RE: DEIR Comments

General Electric Company ("GE") is pleased to submit these comments on EPA's February 1997 Data Evaluation and Interpretation Report ("Report") for the Hudson River PCBs Reassessment Remedial Investigation/Feasibility Study.

COMMENTS OF GENERAL ELECTRIC COMPANY ON

PHASE 2 REPORT - REVIEW COPY  
FURTHER SITE CHARACTERIZATION AND ANALYSIS  
VOLUME 2C -  
DATA EVALUATION AND INTERPRETATION REPORT  
HUDSON RIVER PCBs REASSESSMENT RI/FS  
FEBRUARY 1997

Figure 7. Molar dechlorination product ratio versus fractional molecular weight change relative to Aroclor 1242.

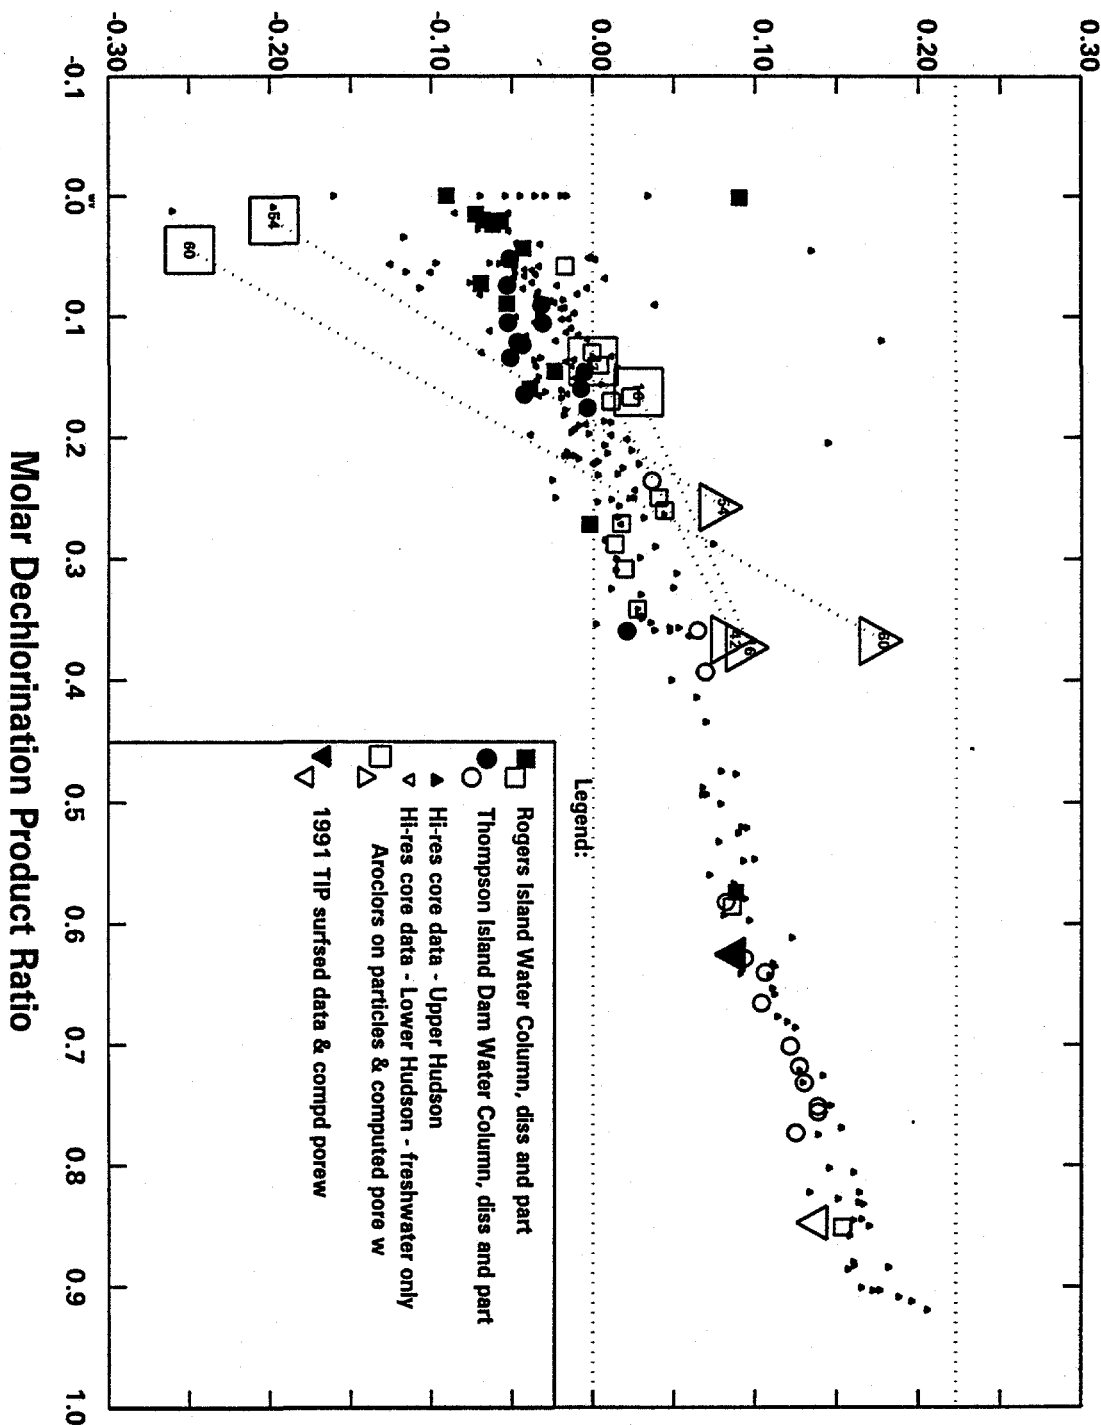
Index values for sediment samples, dissolved and particulate water column samples, and Aroclor standards are plotted in Figure 7, similar to the index plots provided in the Report. The index values of the particulate PCBs sampled at Rogers Island and at the TID (filled squares and circles on Figure 7) center on Aroclor 1242 (large open square symbol at the position (0.14,0.00), demonstrating that the source of these PCBs is unaltered or very slightly altered Aroclor 1242.

Partitioning of PCBs between the solid and the dissolved phases can alter the composition of PCBs and therefore the values of the indices. To demonstrate this, the original Aroclors (large open square symbols) and the dissolved material that would result from partitioning from original Aroclor sorbed to particulate material (large open triangles) are plotted on Figure 7. The

Figure 8. Location of EPA sampling events relative to 1993 hydrograph.

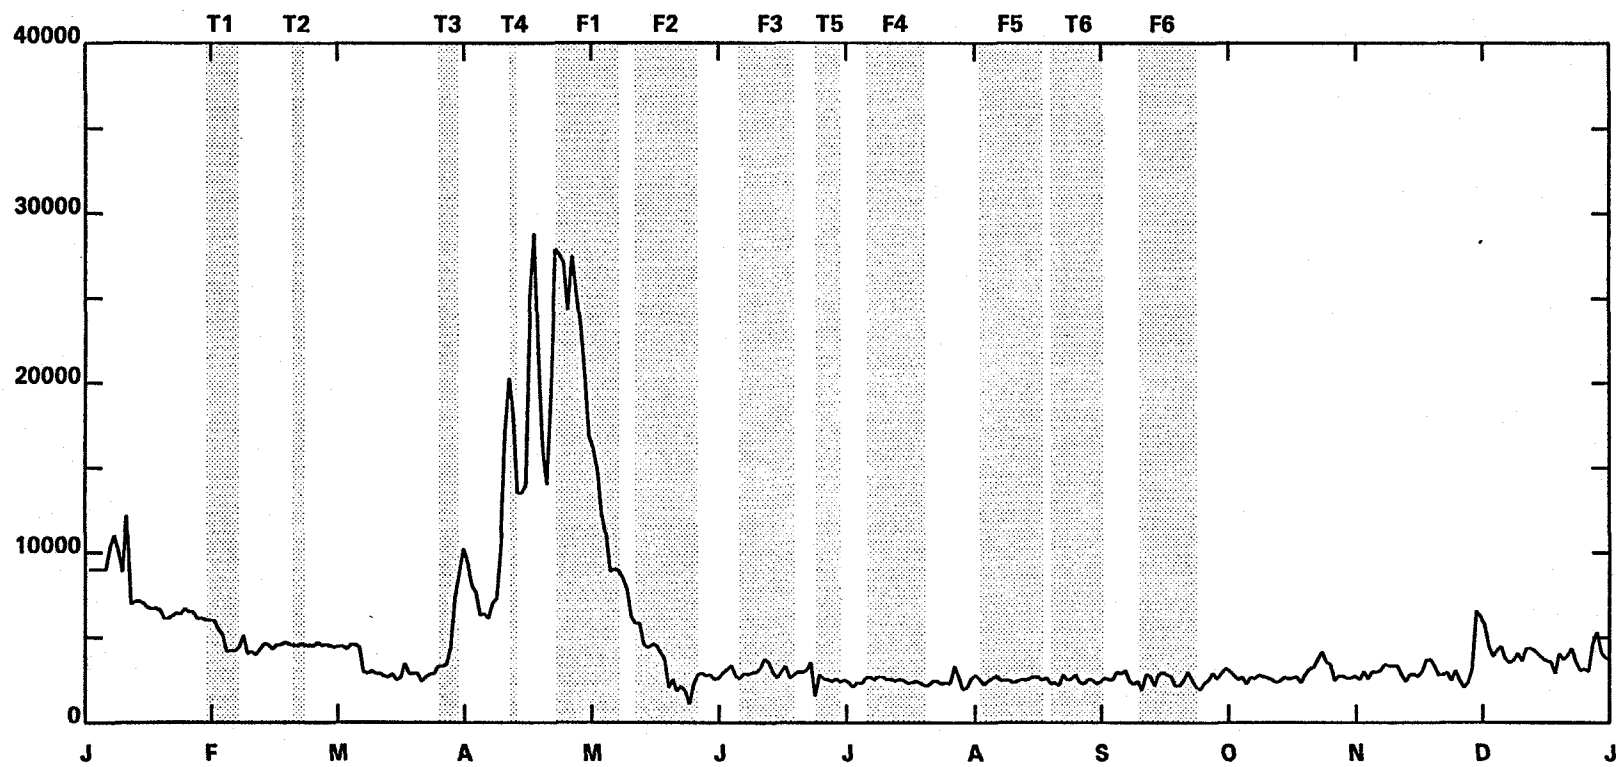
More specifically, the spring high flow event data collected by the EPA demonstrate that a major portion of the total PCB loadings to the system originate from the Hudson Falls plant site area and occur over a very short time frame. Such time variable PCB loading from Hudson Falls is further supported by the observation that the flow weighted average PCB loading from upstream of Roger's Island was approximately 50% of that measured during a transect monitoring event collected under similar flow conditions. The Report attributes this difference to the variable loading dynamics associated with the GE Hudson Falls source. That is, short term PCB loadings captured by the transect sampling were not present in the flow-averaged event samples. Moreover, as the transect 4 data were collected after the river reached an initial peak of approximately 20,000 cfs (Figure 8),

we believe that the EPA data underestimates the actual loading from the Hudson Falls Plant site area. This is because we believe that PCBs are mobilized at lower flows along the rising limb of the spring event hydrograph than that sampled.

Figure 9. Summer 1991 congener peak TIP PCB loading - a) water column load; b) calculated diffusive sediment load; c) unaccounted-for load; d) negative congener loadings.

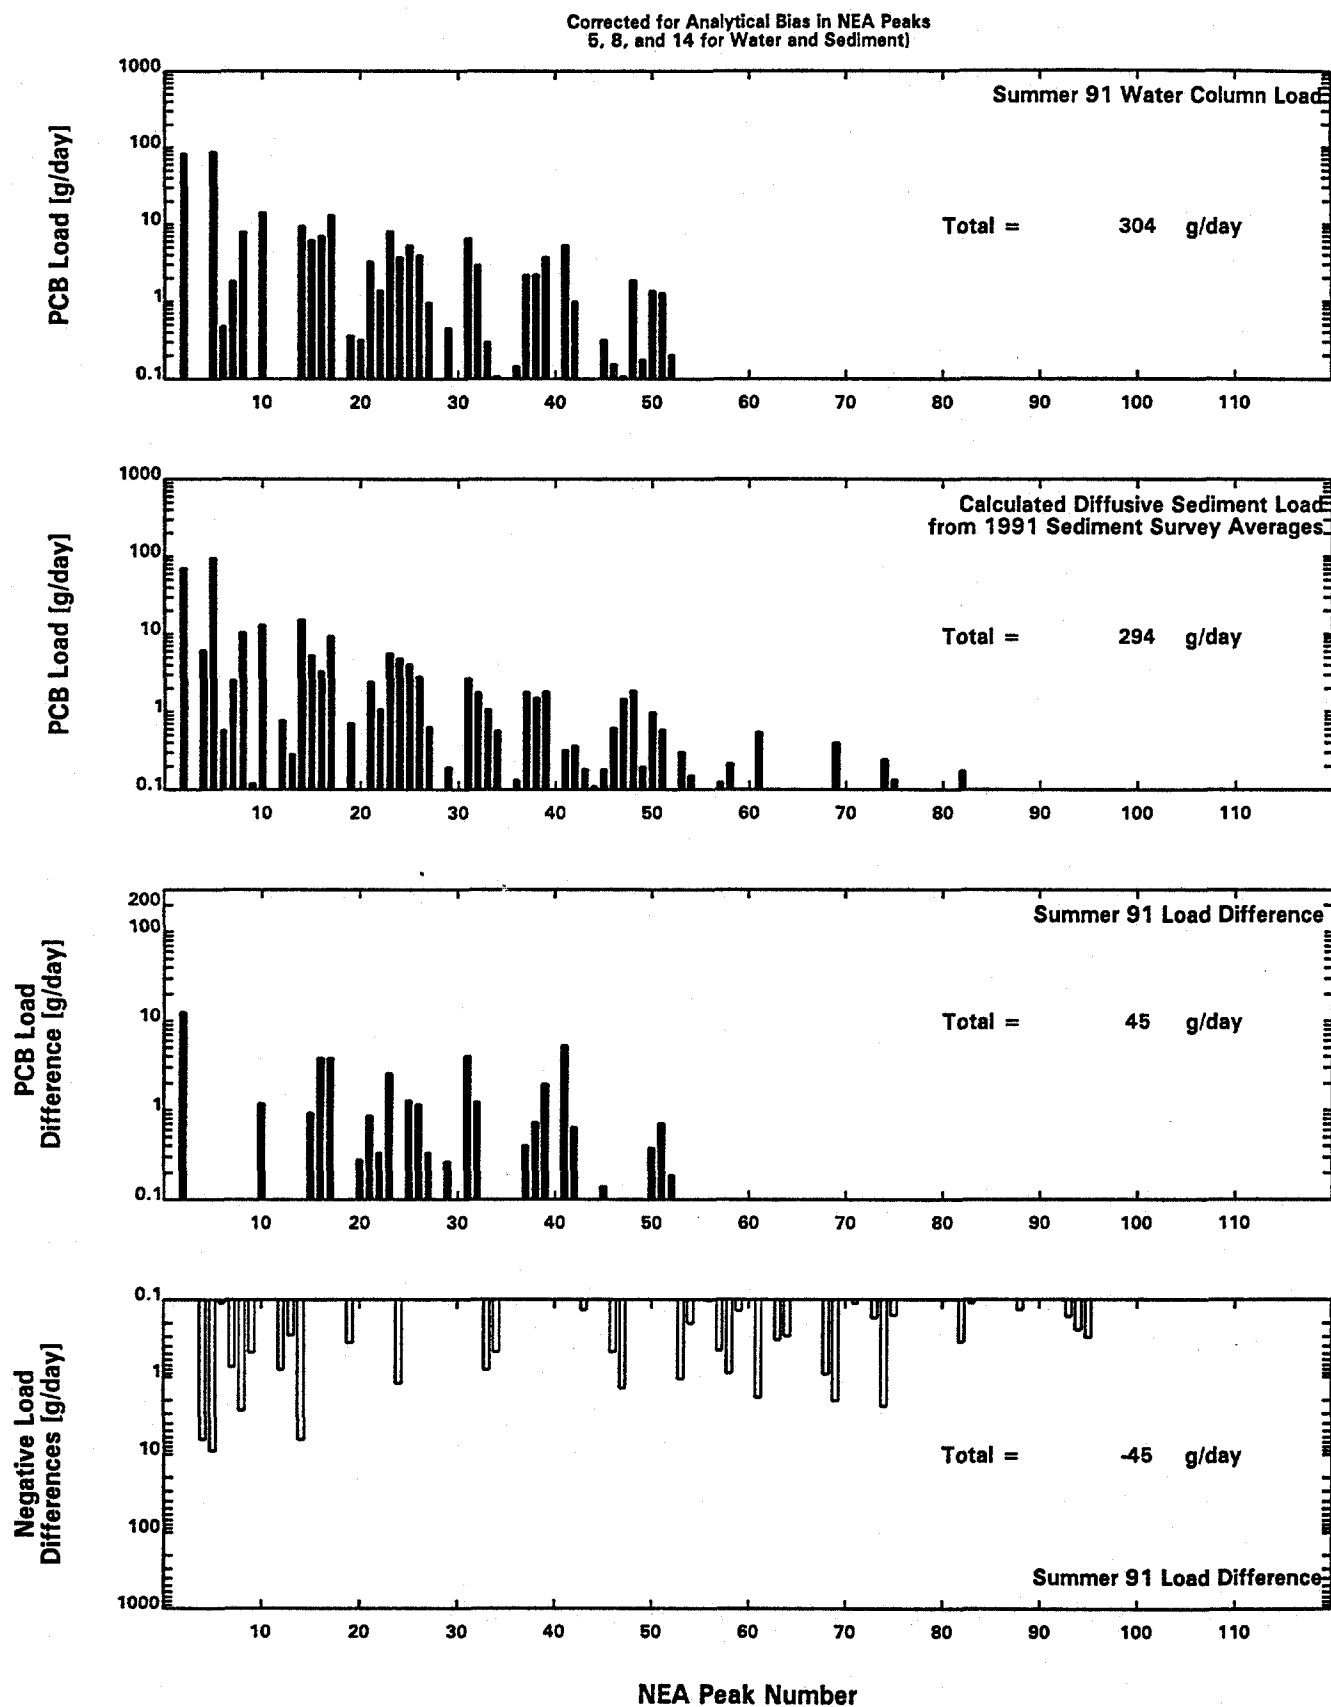
The sediment water exchange coefficient ( $K_f$ ) can be estimated by substituting the water column PCB congener flux estimates for the summer low flow period of 1991 into Equation 10 and adjusting  $K_f$  to minimize the sum of differences in individual PCB congener loading estimates. Negative PCB congener loadings due to detection limits for the higher PCB congeners in water column samples are disregarded (Figure 9; panel d).

Figure 18. Steady state food web model simulation of TTP (exposure: realistic water, top 0-2 cm of sediment, see Table 6).

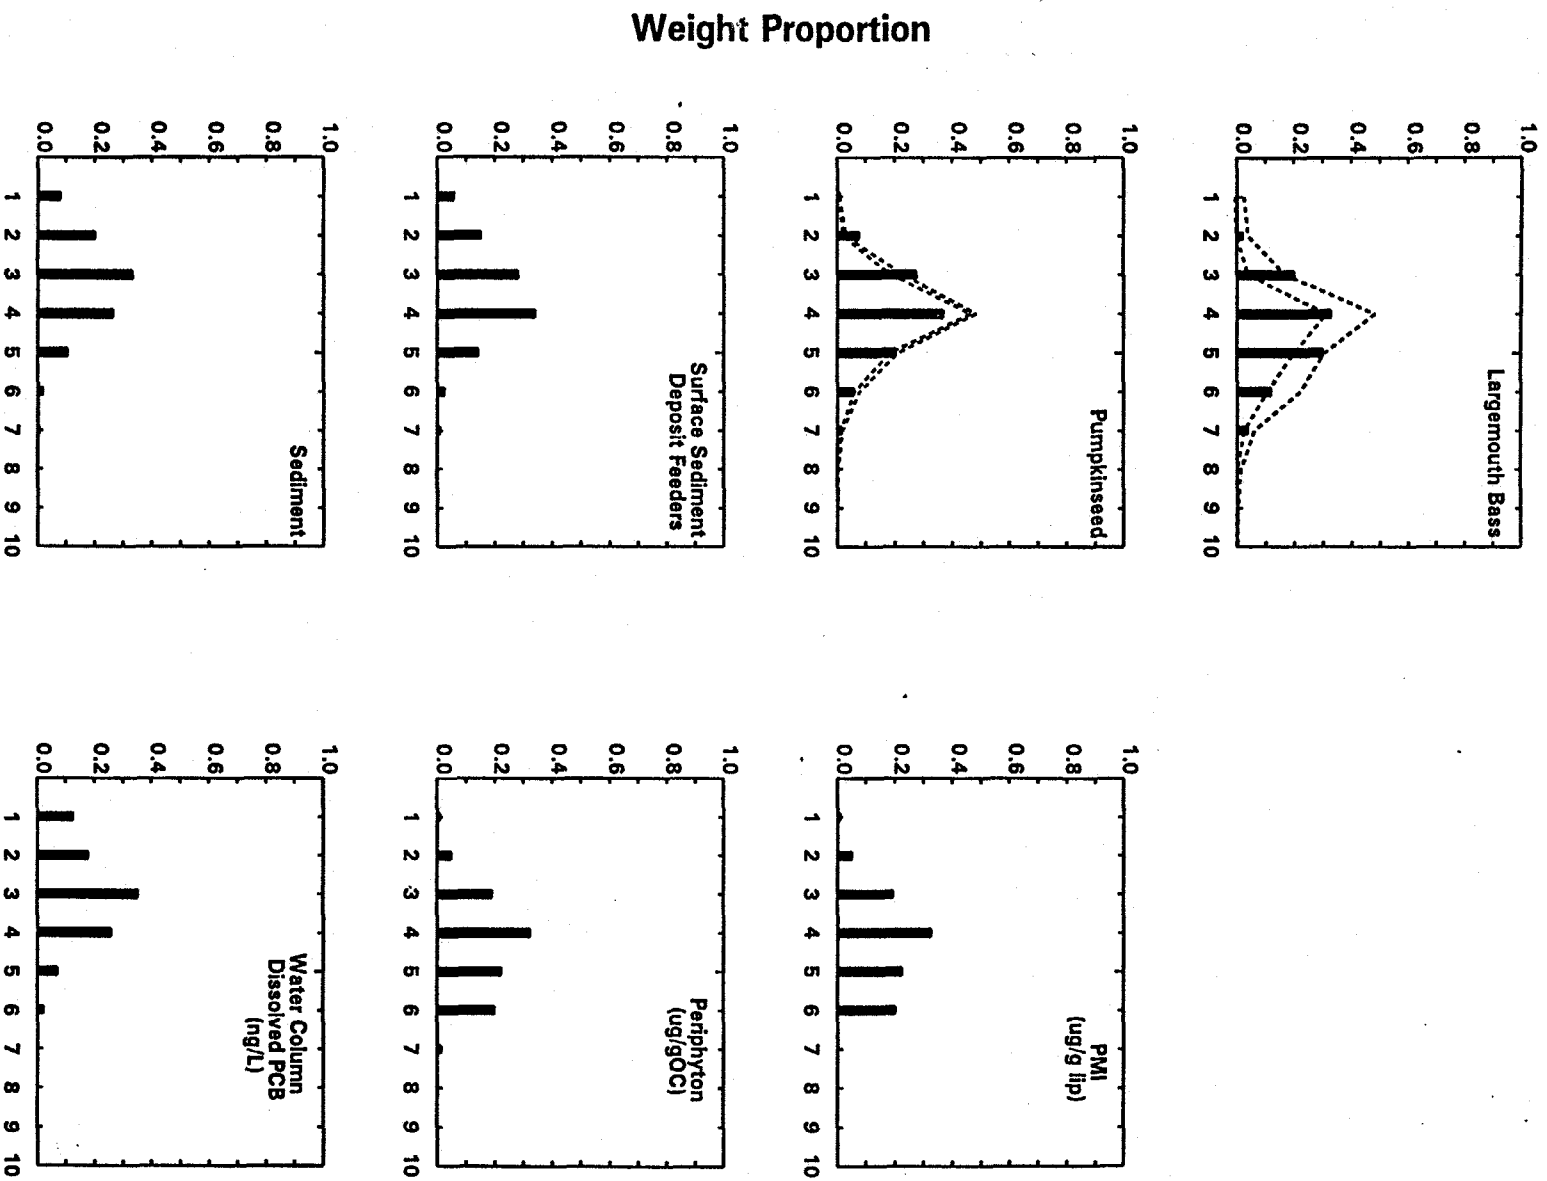
The data best match pumpkinseed homologue distributions computed using the surface slice of the high-resolution cores and the measured water column distribution (Figure 18). The largemouth bass distributions computed using either surface slices, 0-2 cm (Figure 18) or the 0-5 cm layer (Figure 19) best reproduce the observed distributions. As the degree of dechlorination in the exposure sources increases, the model results diverge from the measured homologue distributions

Figure 22. Relationship between PCB congener dechlorination ratios and number of chlorines per biphenyl in EPA Phase II high resolution sediment cores.

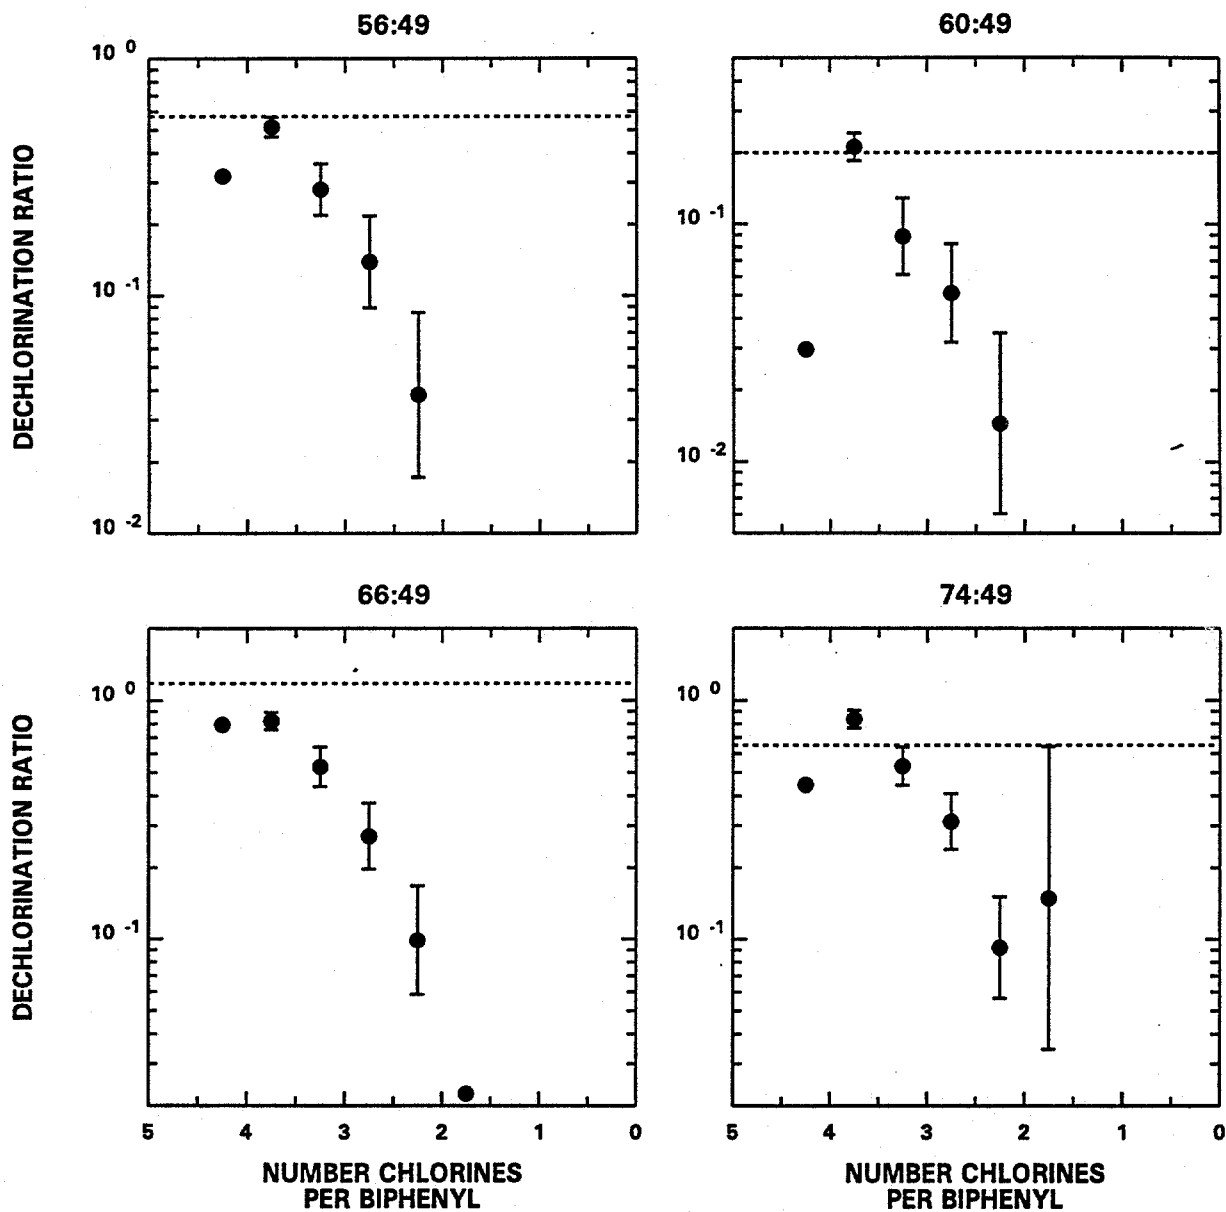
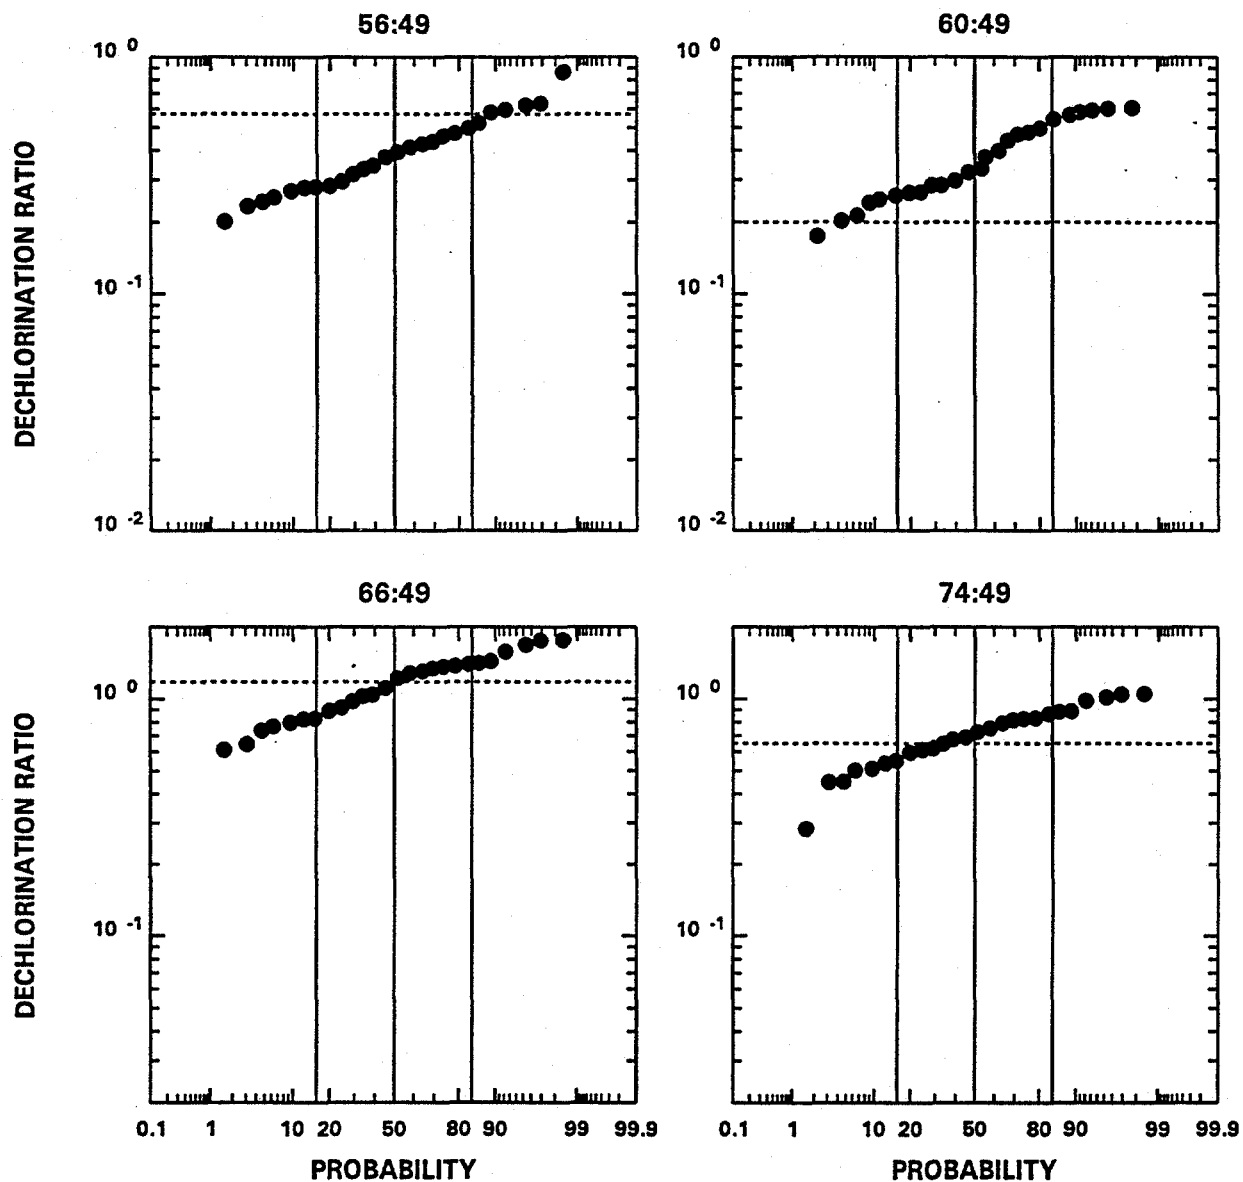
These ratios decline as dechlorination proceeds. For example, four of these ratios are plotted against the number of chlorines per biphenyl (Cl/BP) using high-resolution core sediments from the Upper Hudson (Figure 22). The dashed lines indicate values of the ratios and Cl/BP for Aroclor 1242. The ratios in the sediments approach the Aroclor 1242 value in samples in which Cl/BP approaches the Aroclor 1242 value. In addition, values of the ratio decline in dechlorinated sediments.
